Environmental Restoration Record of Decision

**Hudson River Waterfront - DeLaval Property
City of Poughkeepsie, Dutchess County, New York**

Site Number B00190-3

March 2005

FIGURE 3
 AREAS OF ENVIRONMENTAL CONCERN
 &
 PROPOSED EXCAVATION AREAS
 DELAVAL PROPERTY
 CITY OF POUGHKEEPSIE
 DUTCHESS COUNTY, STATE OF NEW YORK

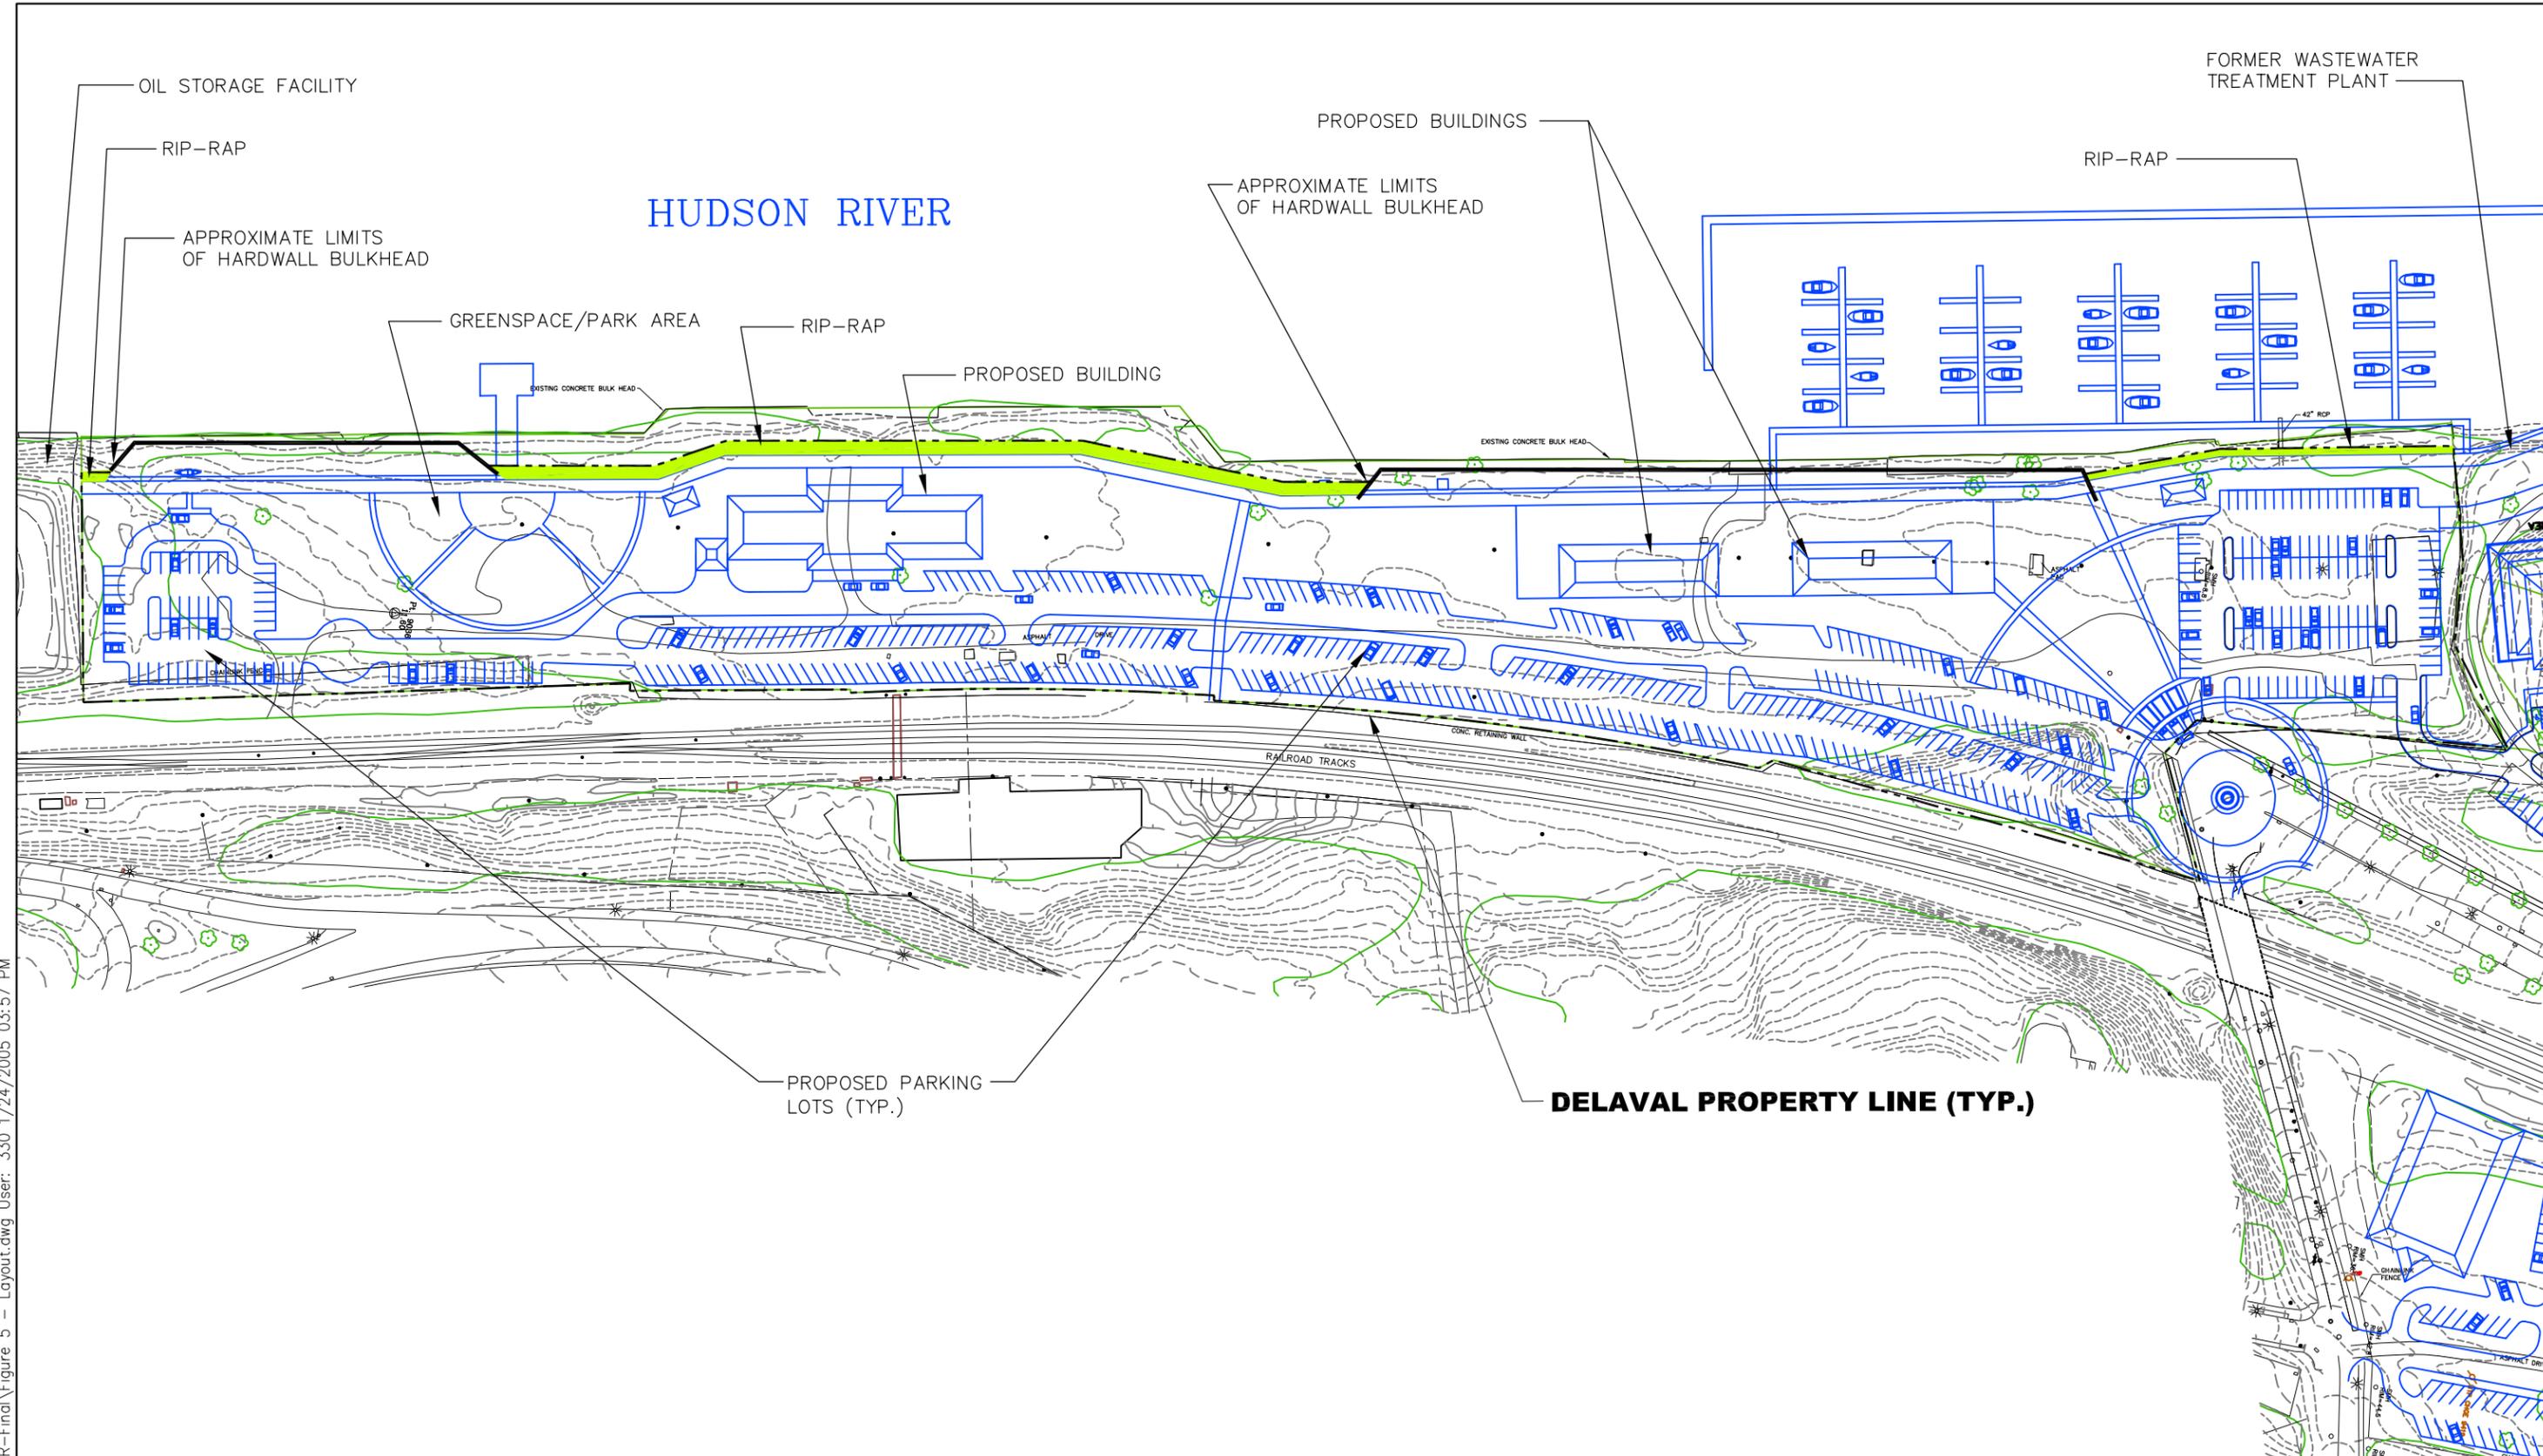
COMMENT 10: There is porosity in the existing bulkhead. How do you stop the site from contaminating the river?

COMMENT 21: I'm very concerned about the mobile contaminants at the bulkhead and their effect on our community's water supply. Why don't you replace the entire bulkhead with vinyl sheeting rather than just the sections you are proposing?

RESPONSE 10: As discussed in Response 9, the primary means of reducing contamination to groundwater, which in turn will reduce contaminant migration, is through source removal. The proposed remedy also includes the placement of vinyl sheet piling along the shoreline adjacent to AOC-1 and AOC-2/3. The purpose of the sheet pile is twofold. First, it would be installed prior to the excavation of the grossly contaminated material, providing a barrier to contaminant migration to the river during the disruptive process of source removal. Secondly, the sheet piling will be left in place to prevent future erosion and transport of any residually contaminated soil. With the source material gone, and only residual levels of contaminants remaining, the sheet pile would serve as an engineering control further reducing the potential for contaminant transport.

RESPONSE 21: There are some contaminants associated with the site that are considered mobile, others that are not. The City's water supply intake is located about 1.75 miles north of the site, extending 1000 feet off shore at a depth of approximately 50 feet. Given the location of and distance to the water intake, there is little if any possibility the supply is threatened by the contaminants identified at the site. The remedy, when implemented, will further eliminate any potential for exposure to site related contamination. In general, mobile contaminants include the petroleum wastes that can potentially migrate on their own as a non aqueous phase liquid (NAPL) or partially dissolve in groundwater. These contaminants have been identified in AOC-1 and AOC-2/3. The contaminants that tend to bind to soil particles, including the polynuclear aromatic hydrocarbons (PAHs), polychlorinated biphenyls (PCBs),

AOC-1 and AOC-2/3 have the vinyl sheet pile proposed as an essential component of the remedy due to the potential for encountering mobile petroleum wastes in those areas, as discussed in Response 10. The remaining areas of the site near the shoreline have been found to either have no impacts or contain low level surface soil contamination, which will be addressed with the minimum 12 inches of clean soil cover over the entire site component of the remedy. Installation of the vinyl sheet pile bulkhead beyond the proposed limits for remediation purposes is not warranted at this time. If it is found during the design or construction that an AOC extends further than expected, an extension of the vinyl sheet pile bulkhead will be considered.
